PUBLIC HEARING: Review Resolution #20-028 Revised Preliminary Plat for Riverstone (Project 17-106, 19-149); Case of Capstone Homes, Inc.

PRELIMINARY SITE & UTILITY PLAN

DATE	12/30/19	PROJECT ADDRESS	RIVERSTONE DEVELOPMENT
PROJECT TITLE	RIVERSTONE ADDITION (PRELIMINARY PLAT REVISION)		
PROJECT #	17-106		
DEPARTMENT:	Community Development – Planning Division		
TECHNICAL REVIEWER:	Name: Tim Gladhill, Community Development Director Phone: 763-433-9826 Email: tgladhill@cityoframsey.com

PRELIMINARY SITE & UTILITY PLAN

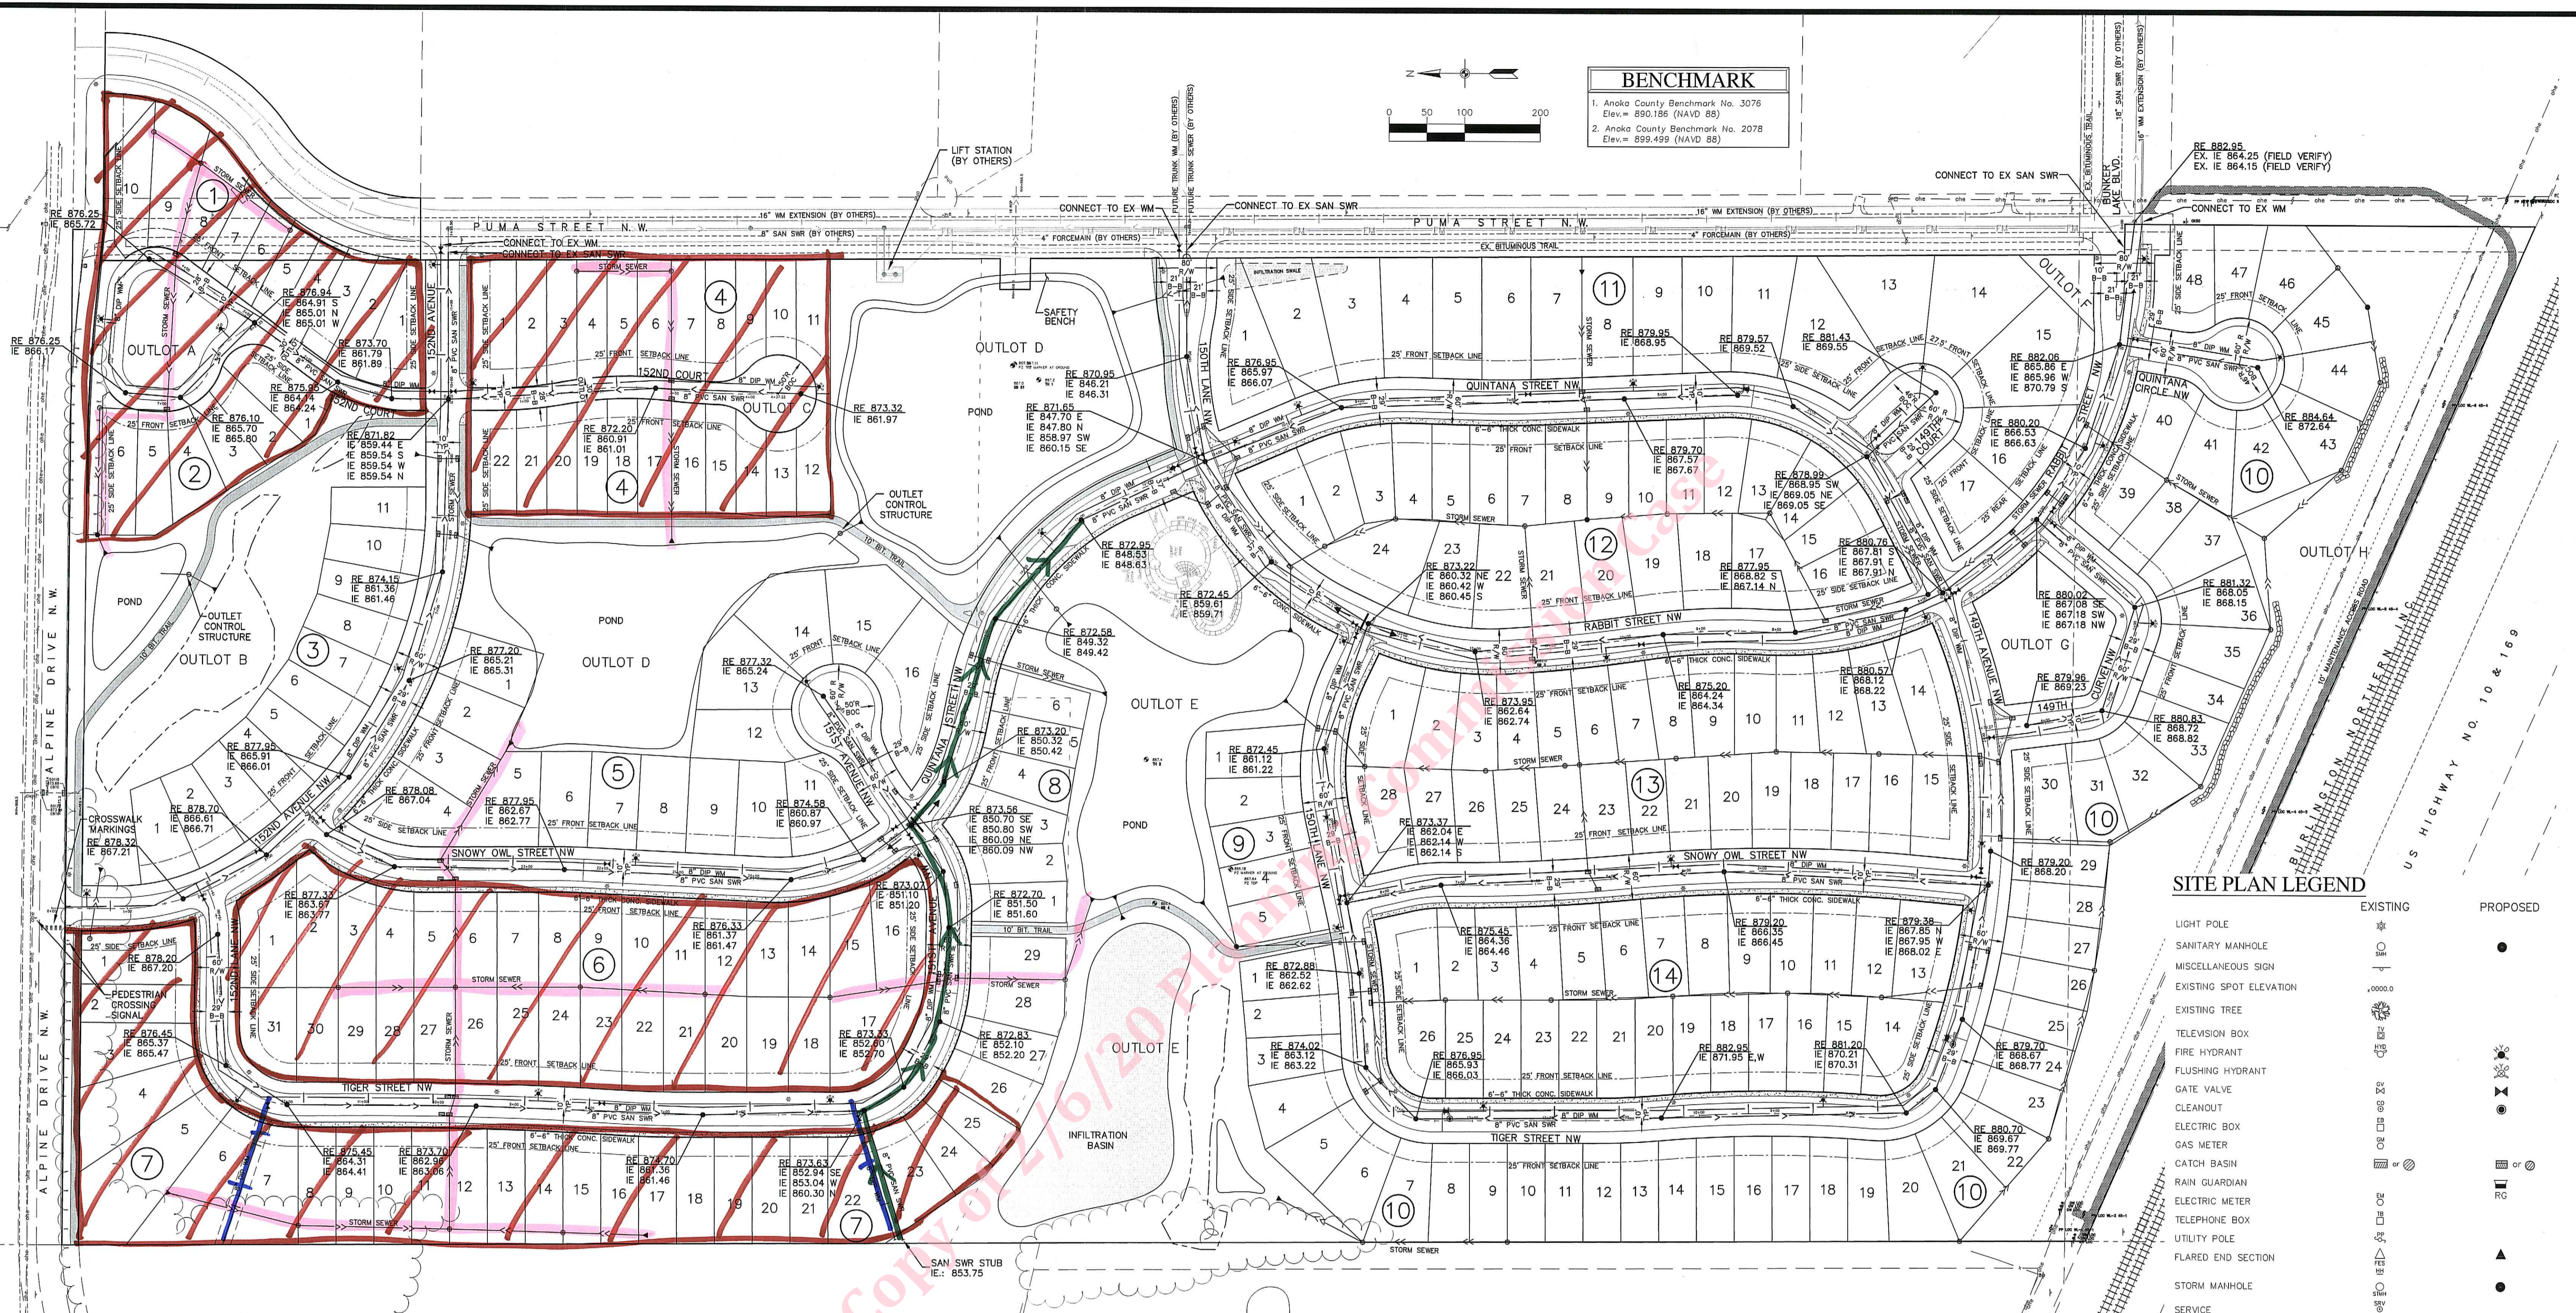
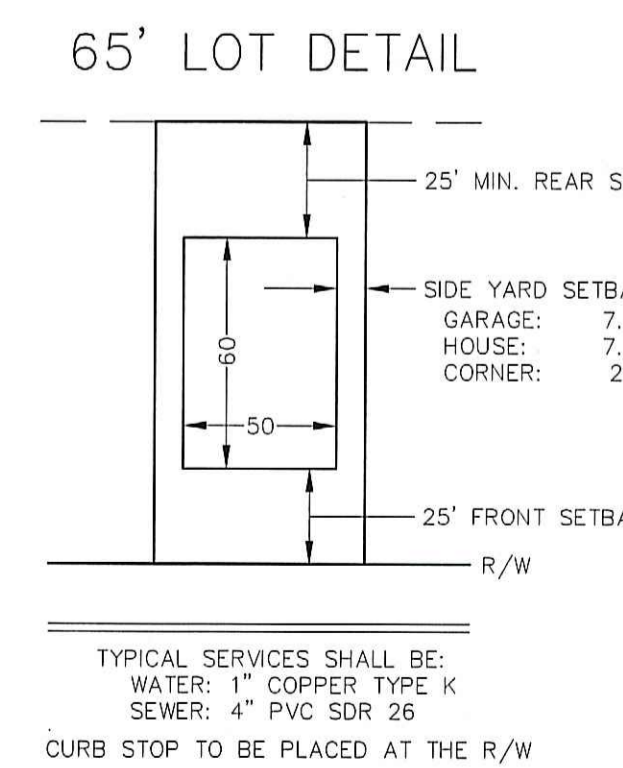
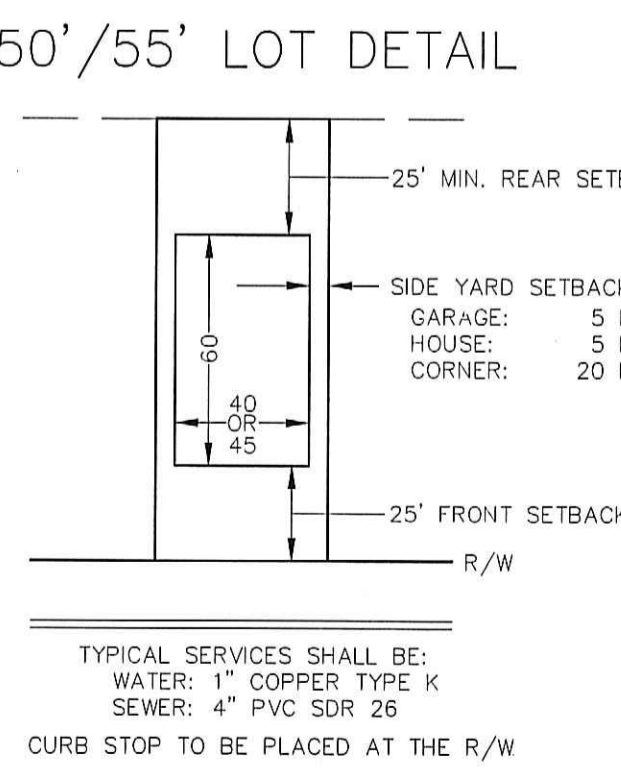
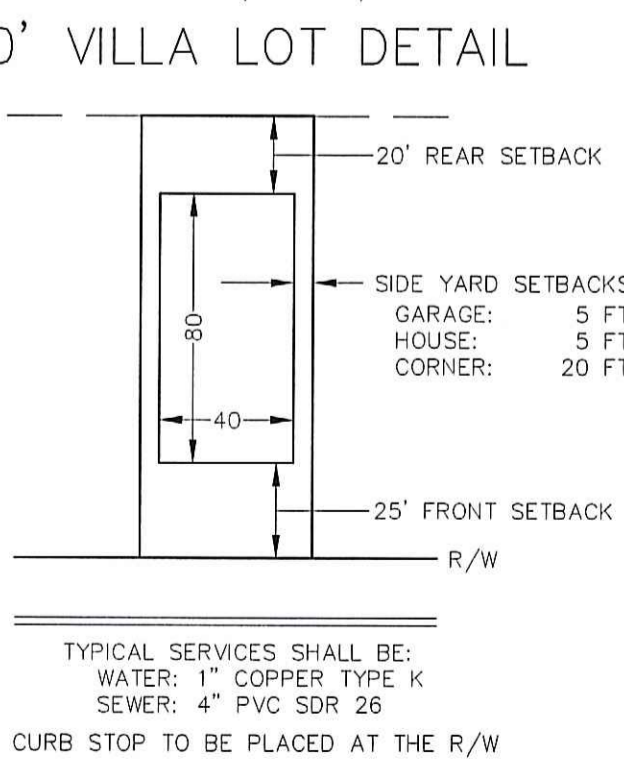
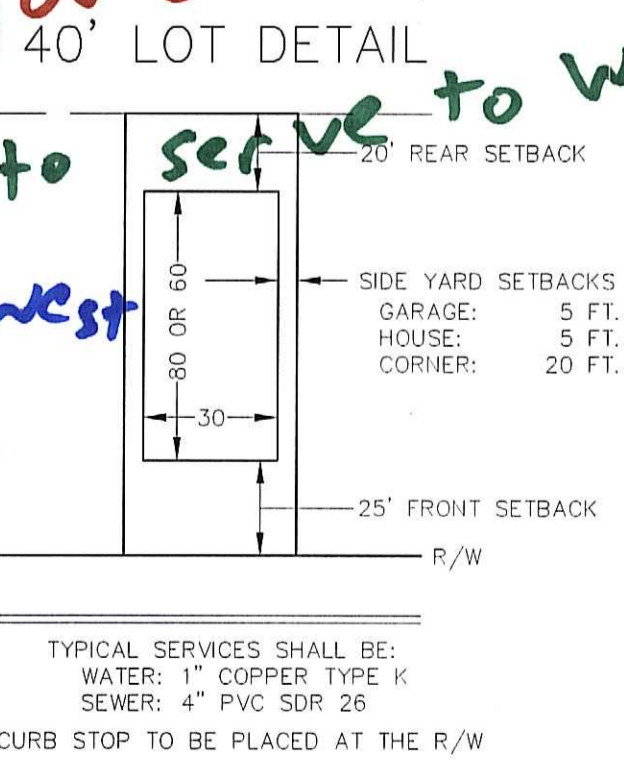
Utility Changes:

- Sanitary sewer and water depth changed to serve parcel directly to west between Block 6 and 8
- Sanitary sewer changes across Blocks 1, 2, 4, 6 & 7
- Watermain stubbed west to serve parcel directly to west through block 7

Please note that the utility changes were requested to serve the parcel to the west (currently under application for Sketch Plan from BK Land Development)
